New off-leash area at Parkway Forest Park

Stakeholder meeting

Meeting date: October 19, 2022, 6:00 pm

Proposed Design

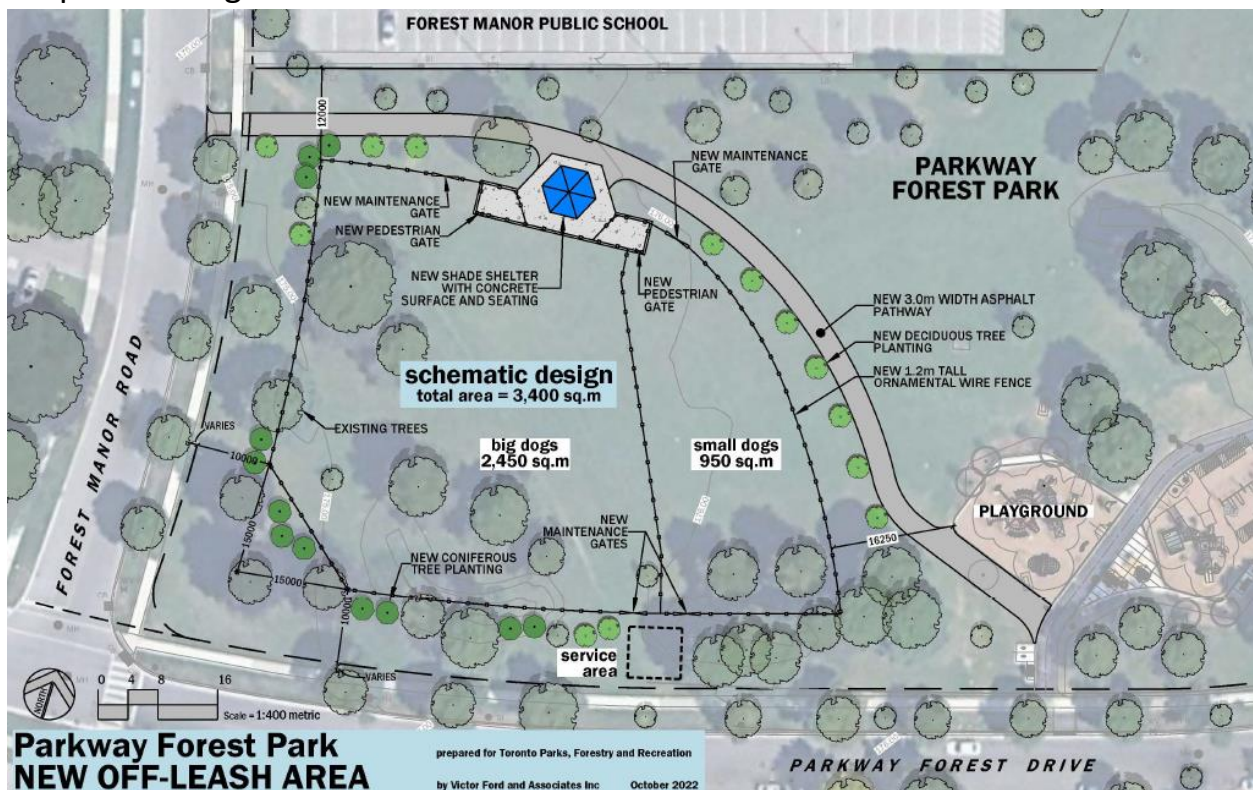
- The group was generally supportive of the concept plan. No significant changes were requested.
- There was a request to consider a mixed-size dog area and/or to increase the proportion of the small dog area. Jeremy explained that PFR had prepared an initial design using these general proportions, which had been followed. Based on community input this sort of change is possible if there is general agreement. No objections were raised.

- Separate bottle fillers were requested for the playground and OLA areas. This is what is currently planned.
- There was a request to include a dog bowl on the bottle filler. Parks' tech. services do not support dog bowls for cost, maintenance and hygiene reasons.

- There was a question whether the bottle filler would be installed on a hard surface to help prevent muddy conditions. Bottle filler will be installed on a hard surface.

- There was a discussion of colour palettes for the shelter and cluster seating. Suggestions included to follow the colours of the recently built playground, or the seating area near the community centre. It was decided that VFA would provide some mock-ups for consideration, based on the conversation.

- Community members requested to review mock-ups at end of meeting summary and comment with preferences.
- There was discussion about preferred materials for cluster seating (metal vs. recycled plastic timbers) and whether the metal option might heat up too much in the sun. It was clarified that the cluster seating will be located under the shelter, out of the sun, so will not be expected to heat up significantly, though it may be very cold to the touch in winter. Based on this, options will be presented with a focus on the recycled plastic timbers.

- Options with both materials are included in the mock-ups at the end. There was support for including seating around trees within the OLA, and interest expressed in the Berczy Park example that was presented.

- It was noted that the bike racks near the playground are well used, and that additional racks would be appreciated. Work to include bike racks in the final design was deferred by the design team.
